REPORT OF TEST
USATECOM PROJECT NO. 4-3-1000-02-A ✓
MILITARY POTENTIAL TEST OF COMMERCIAL OFF-THE-SHELF
HELICOPTERS AS BASIC ROTARY-WING INSTRUMENT TRAINERS

ERRATA

6 MILITARY POTENTIAL TEST OF COMMERCIAL OFF-THE-SHELF
HELICOPTERS AS BASIC ROTARY-WING INSTRUMENT TRAINERS ;

Figure 1

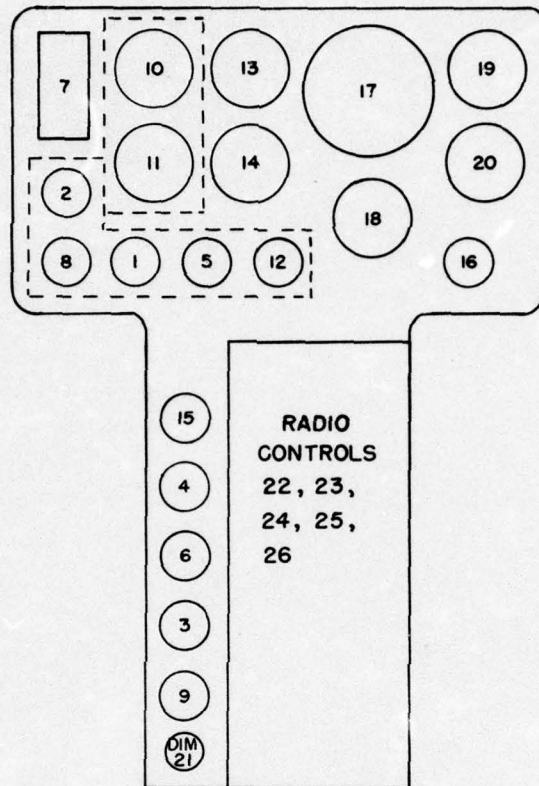
2.2 It appears that a number of indicators are unnecessarily placed on the upper instrument console. Without these the basic instrument group could be moved closer to the instructor. This is considered desirable, since it will provide a less oblique view of the basic instrument group by the instructor. It should also reduce the clutter of the basic panel.

2.2.1 Figure 1 indicates a panel that, without consultation with instrumentation engineers, is considered preferable.

2.2.1.1 In this proposed location, it would be desirable to provide a lock for the ignition switch. It definitely should not be located adjacent to the AN/ARC45 control.
